S.R. 92 AT HOOD AVENUE REALIGNMENT PROJECT CITY OF FAYETTEVILLE

ADDENDUM No. 2

**S.R. 92 AT HOOD AVENUE REALIGNMENT PROJECT
CITY OF FAYETTEVILLE**

RE: Addendum No. 2 dated July 10, 2015

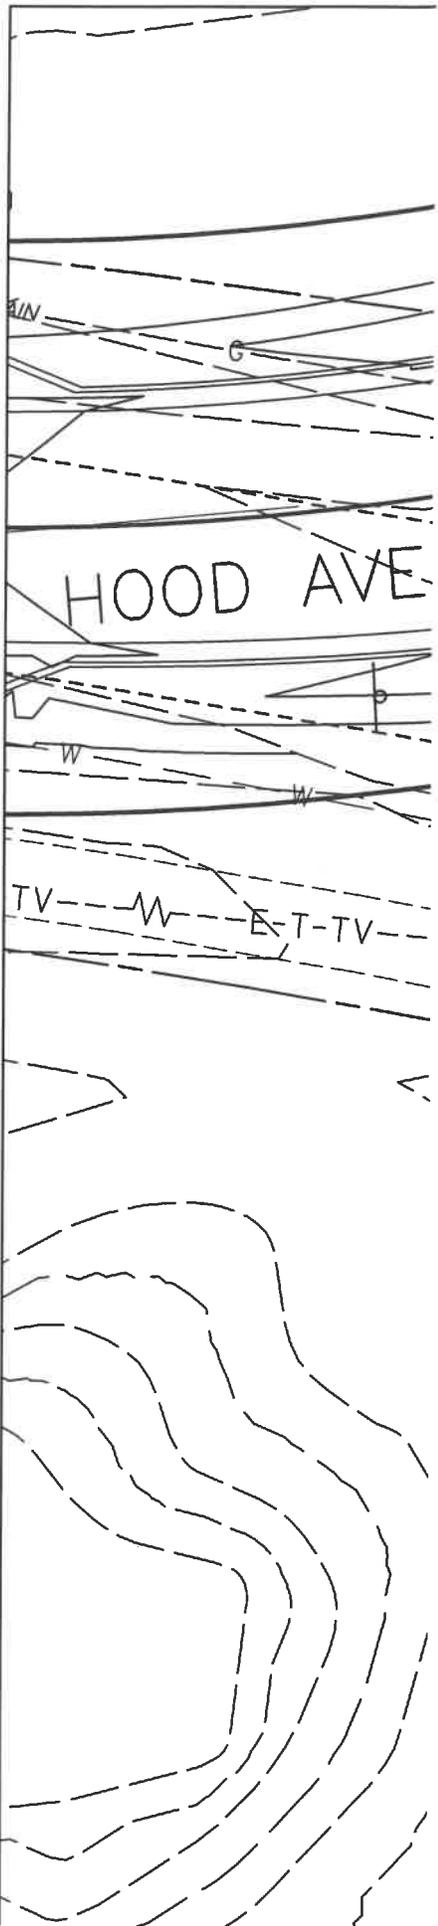
3. **QUESTION:** All parcels, property lines, and easements need to be labeled on construction plans.

RESPONSE: In general, parcels, property lines and easements are shown on the Mainline and Secondary Roadway Plan and Profile sheets (13-01 through 14-10). Some parcel numbers have inadvertently been left off various parcels. Please use the attached Overall Parcel Summary Sheet as reference.

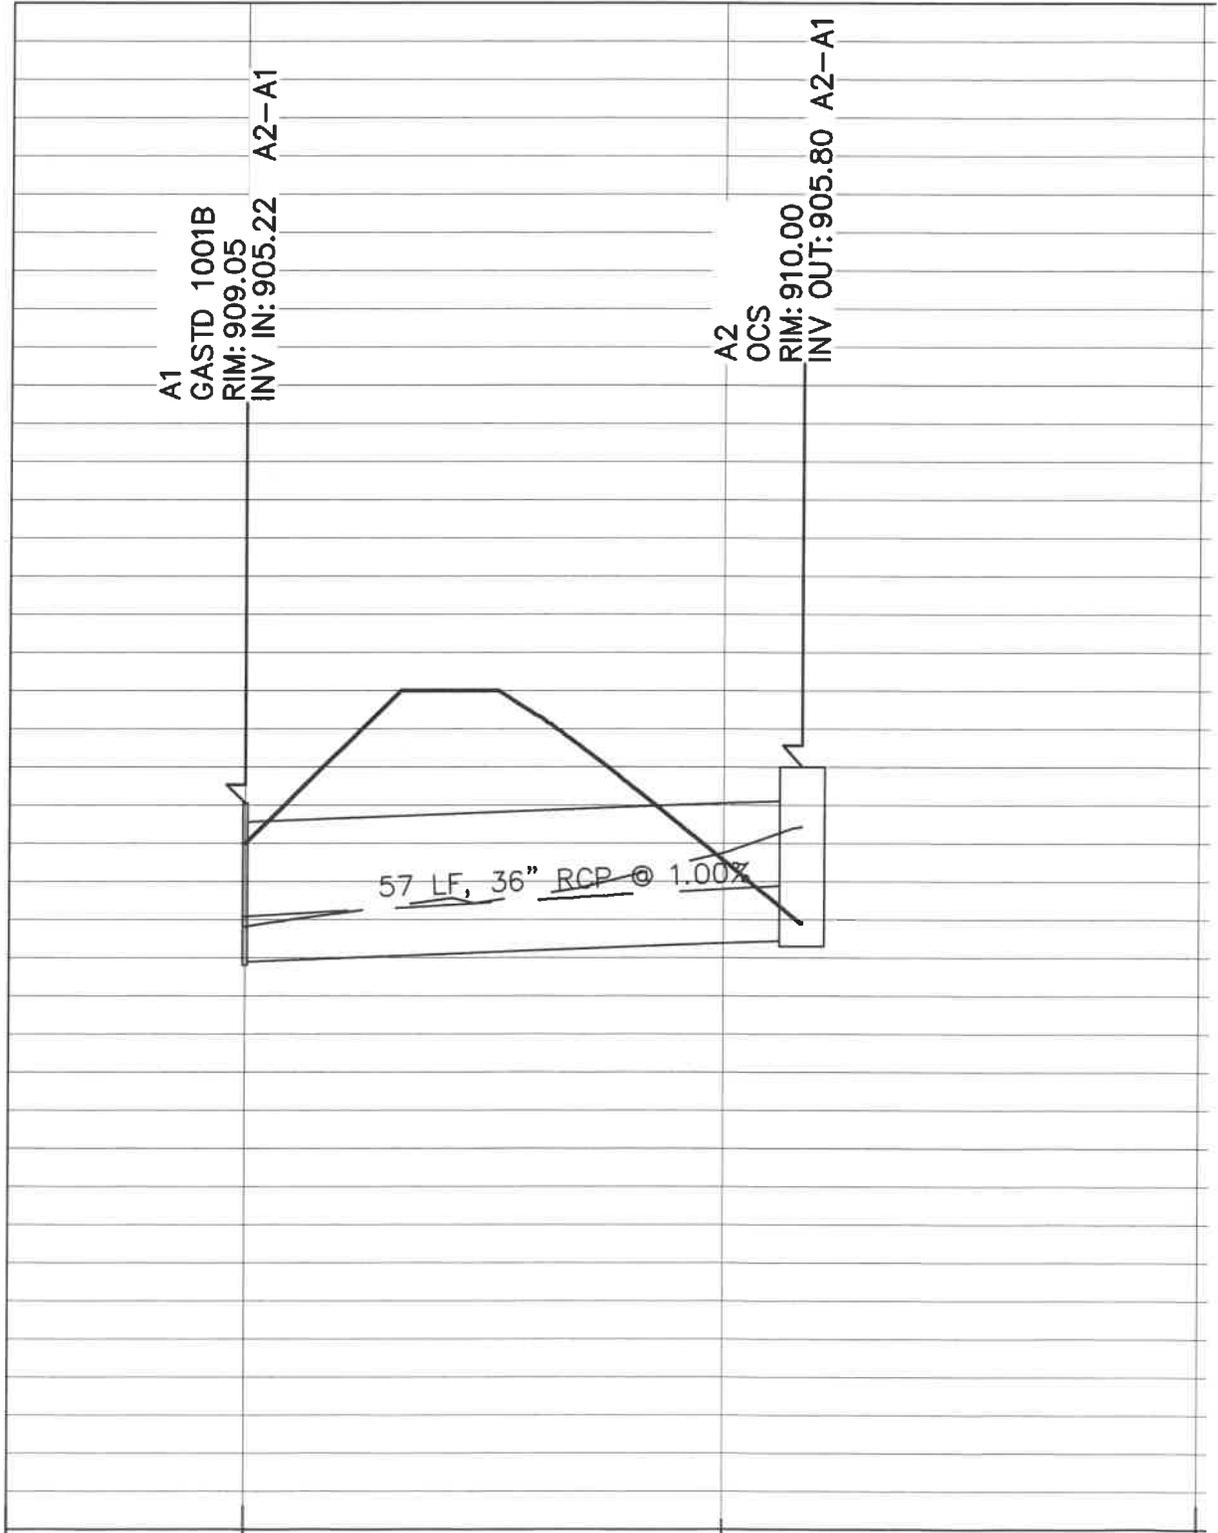
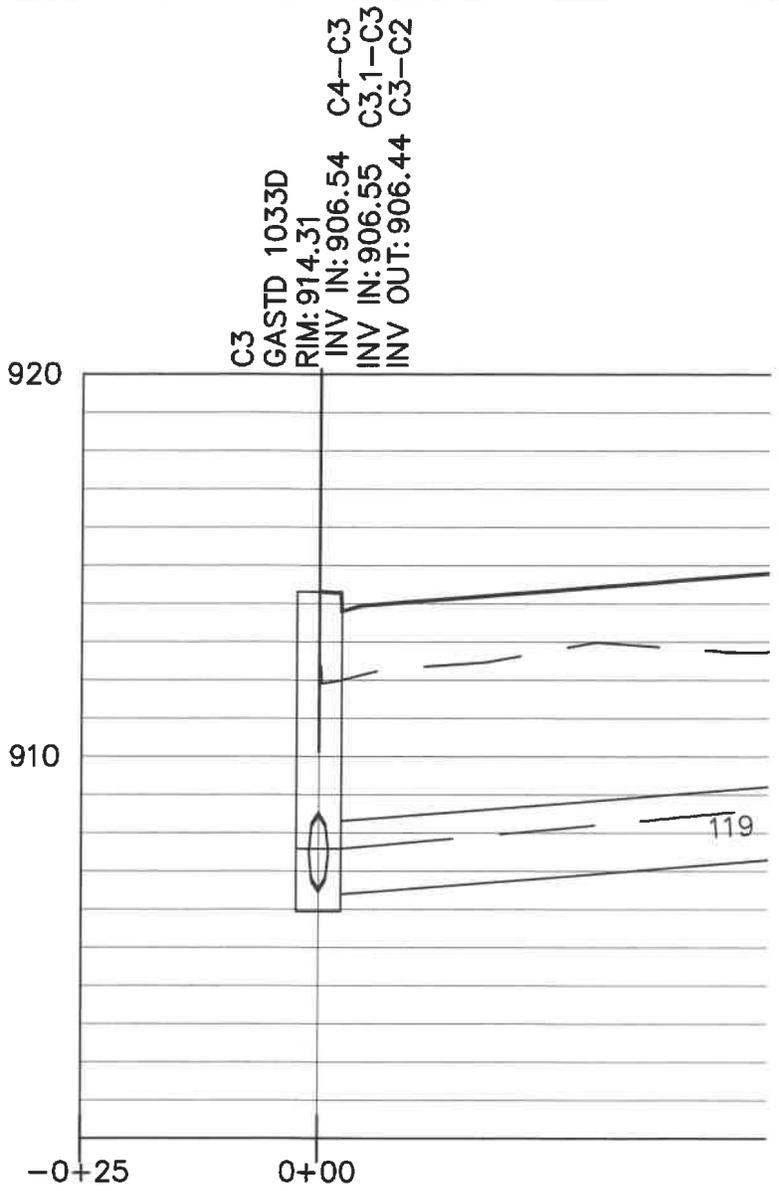
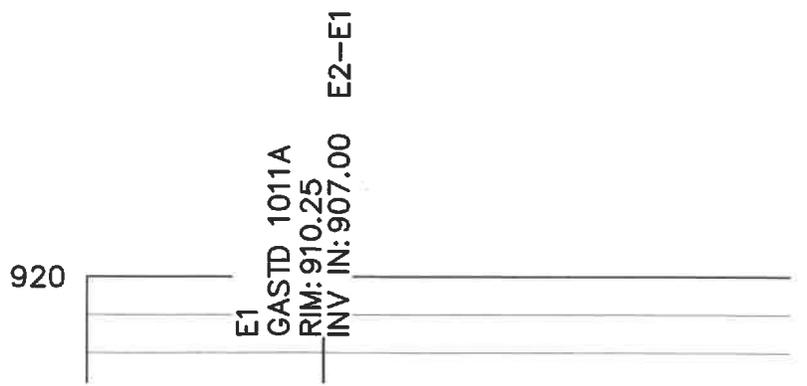
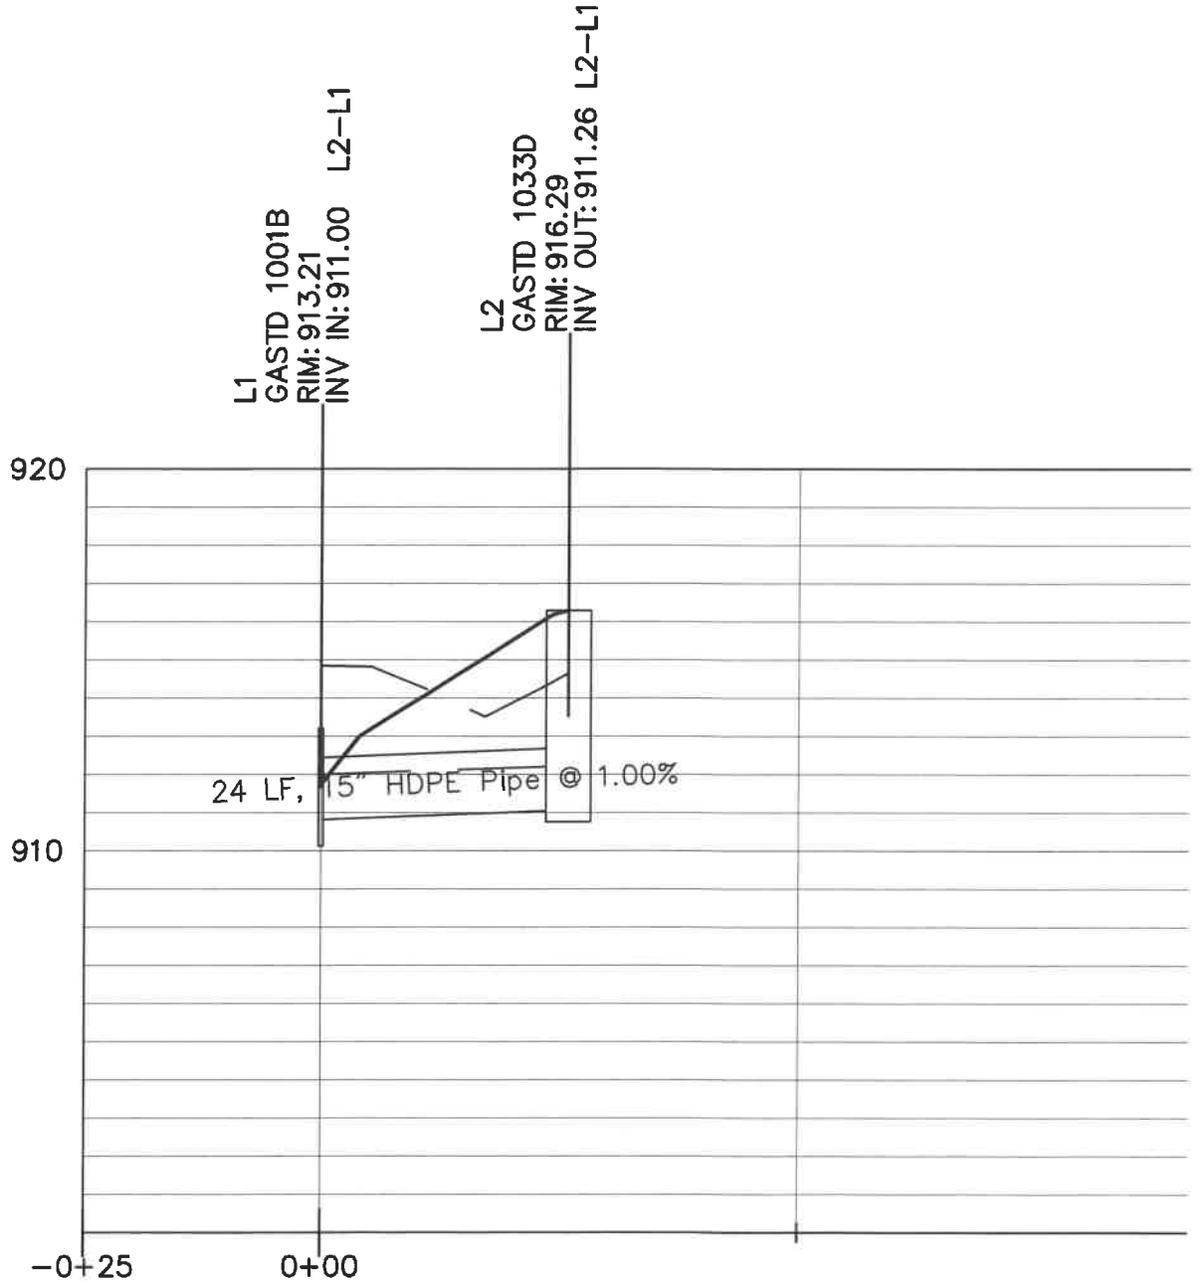
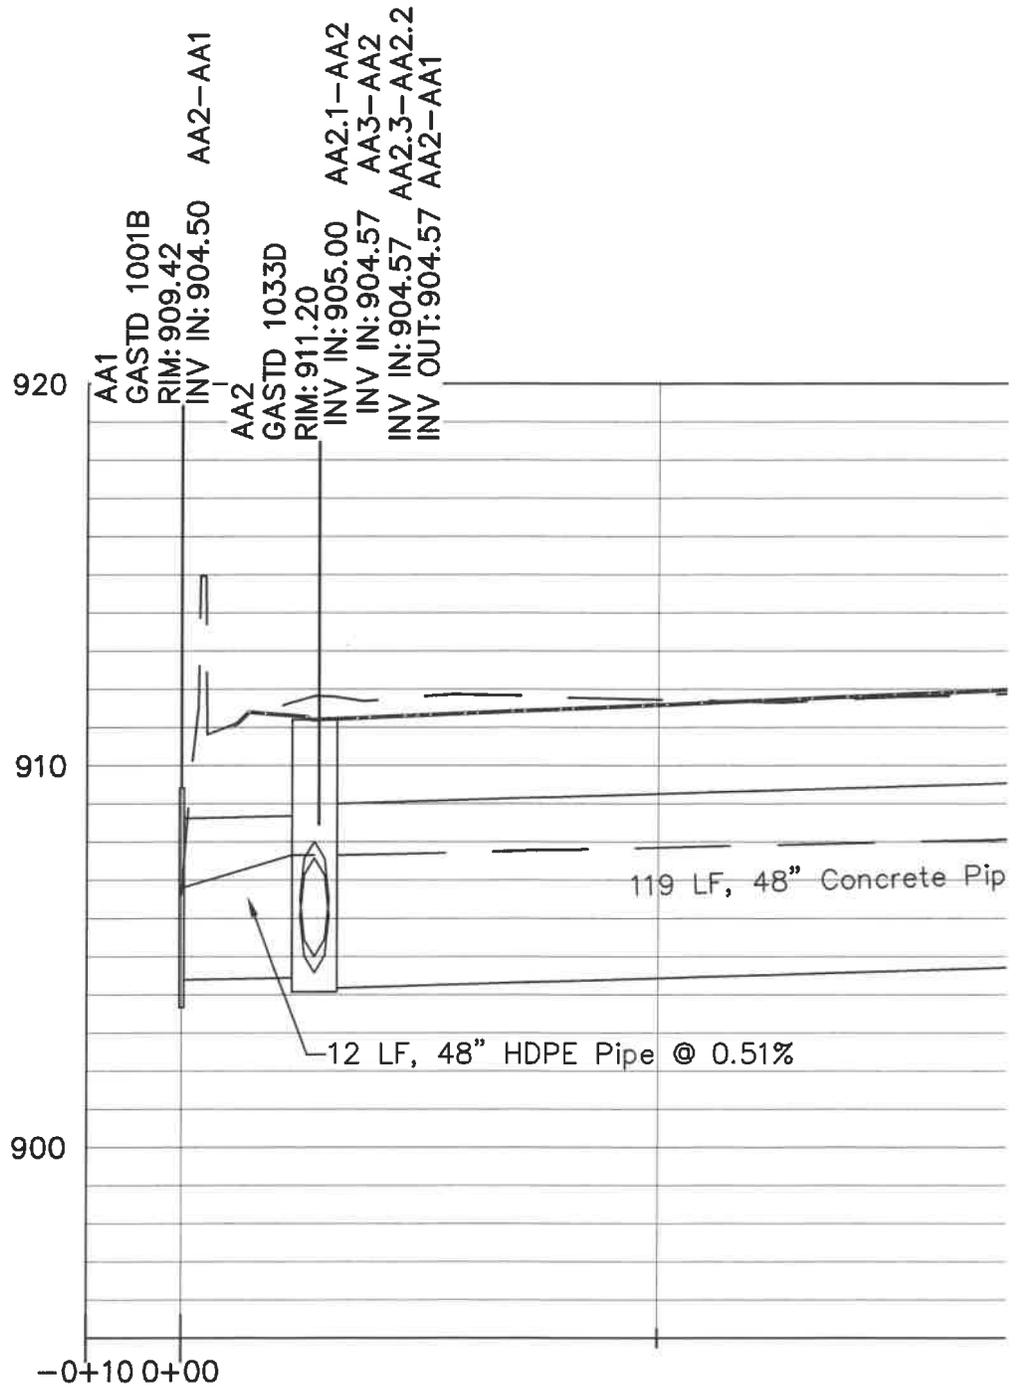
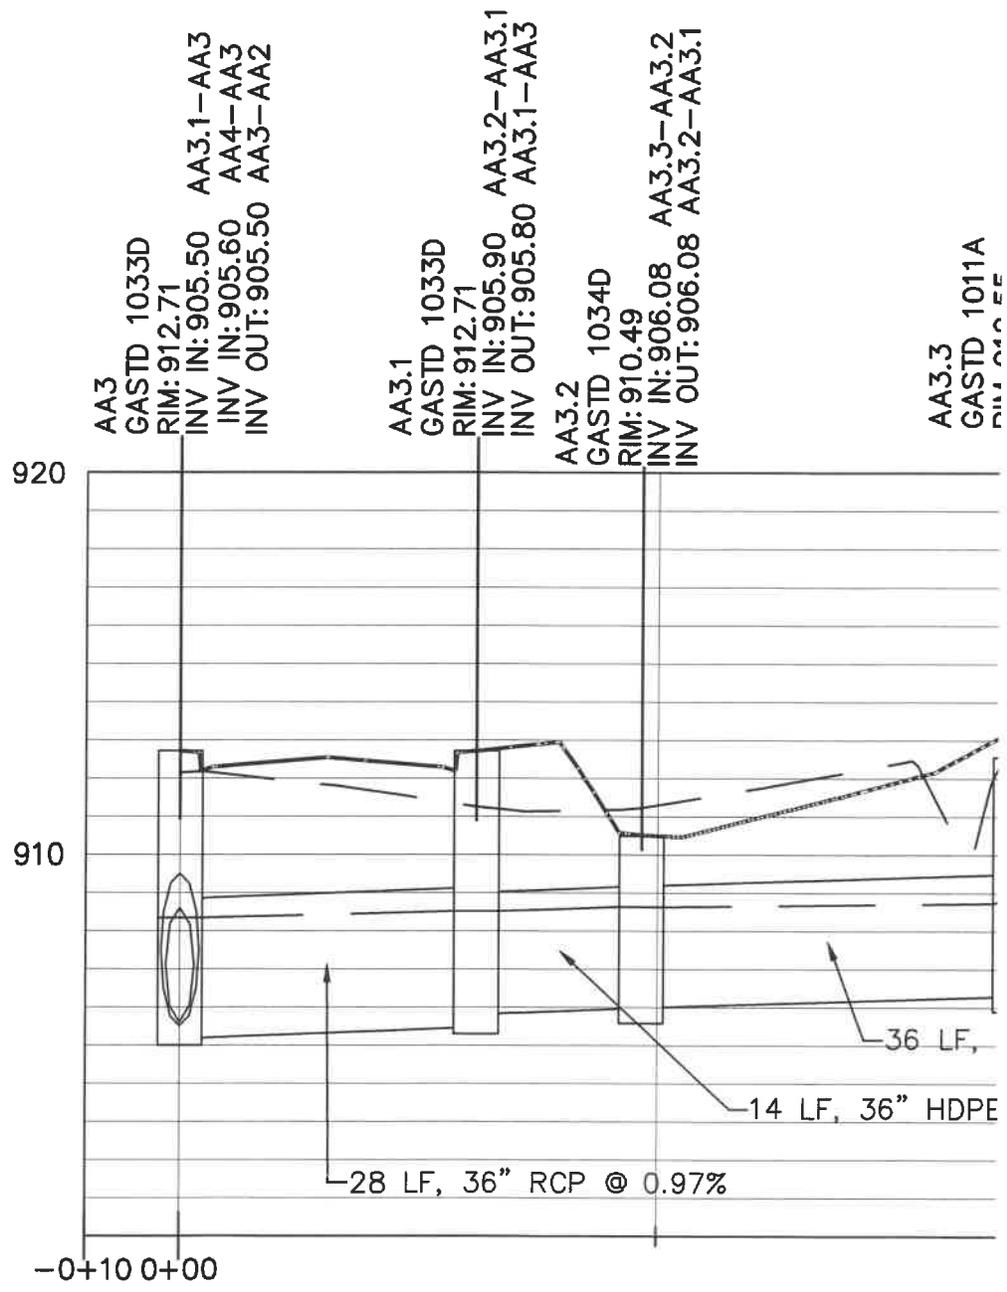
13. **QUESTION:** Looking over the storm drain details it is unclear as to which lines have been designated as storm drain or side drain. Would the City provide further information as to which line is what?

24. **QUESTION:** Sheet 22-05 is missing pipe profile for BB5 to BB6 as shown in plan view on Drawing 14-10 and 22-05.

RESPONSE: In general, storm drain pipe can be considered all pipes under the travel lanes of the roadways, commercial driveways, or pond outlets. Storm drain pipe shall be RCP. Side drain pipe can be considered as all other piping. Side drain pipe shall be HDPE. Sheets 22-01 through 22-07 have been revised accordingly and are provided with this addendum.

RESPONSE: The missing pipe profiles are added to Sheet 22-05 and are provided with this addendum.
